Re: Country Club Estates – Chapter 40B Comprehensive Permit

In response to comments from Amory Engineers, P.C. dated May 18, 2020 for Country Club Estates located off Plymouth Street, Silva Engineering Associates provides the following responses:

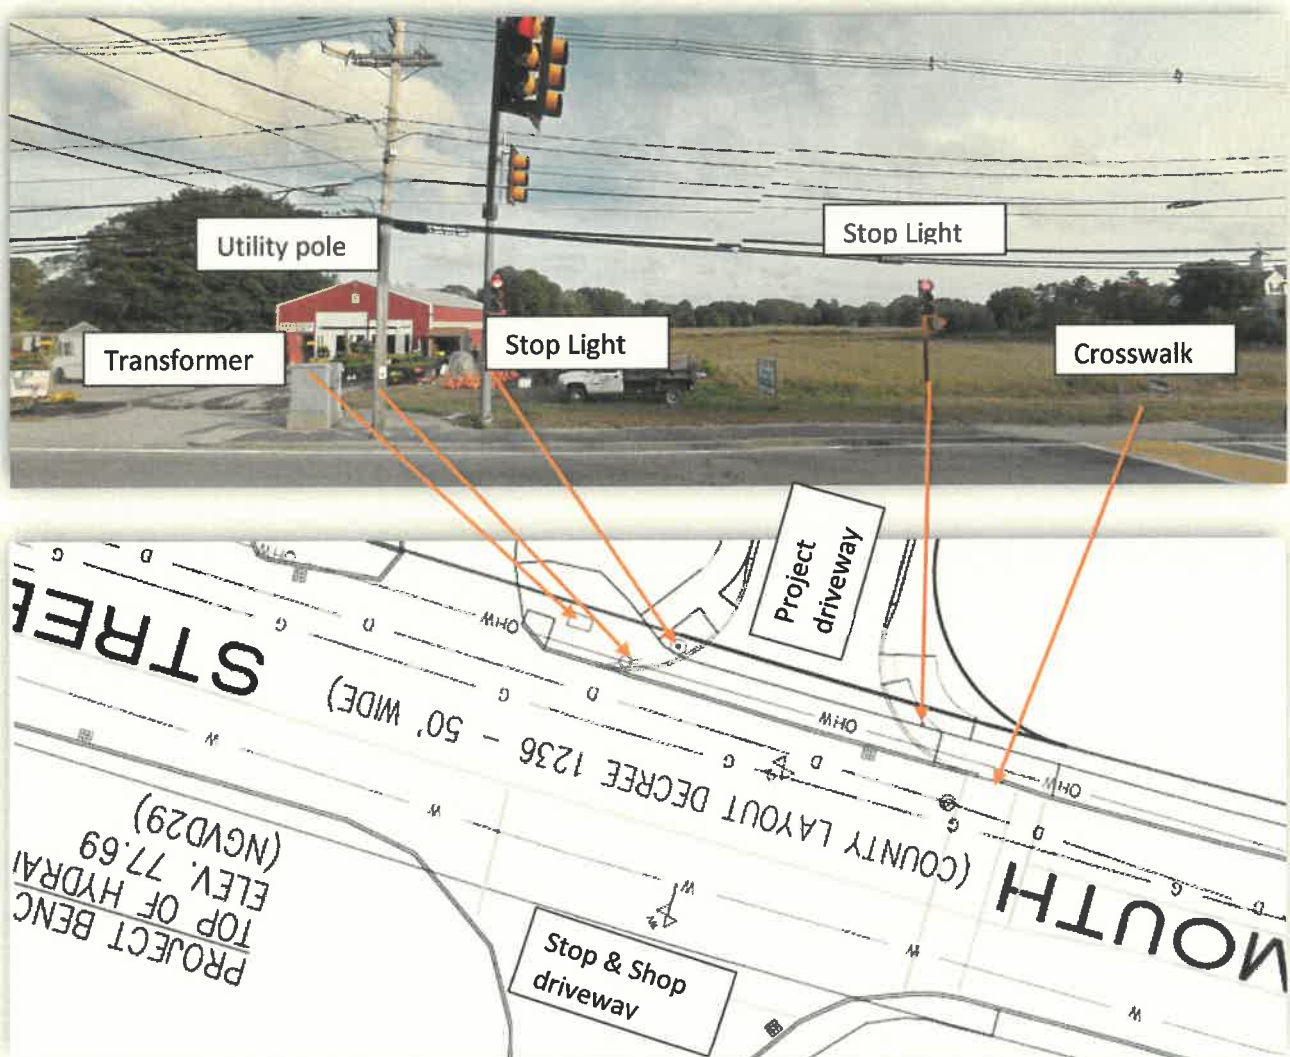
Armory Comment 1: As noted above, the access roadway is proposed to access Plymouth Street at the signalized intersection at the Stop & Shop supermarket east driveway entrance. The centerline of the proposed roadway appears to be approximately 10- to 15-feet west of the centerline of the Stop & Shop driveway across Plymouth Street. The centerline of the proposed roadway should be in line with the centerline of the Stop & Shop driveway centerline.

SEA Response: **Roadway alignment was chosen to eliminate relocation of a utility pole and a ground transformer. The alignment is still within reason for safe traveling. The images below illustrate the elements that would have to be relocated in order for the 10-foot shift in alignment.**
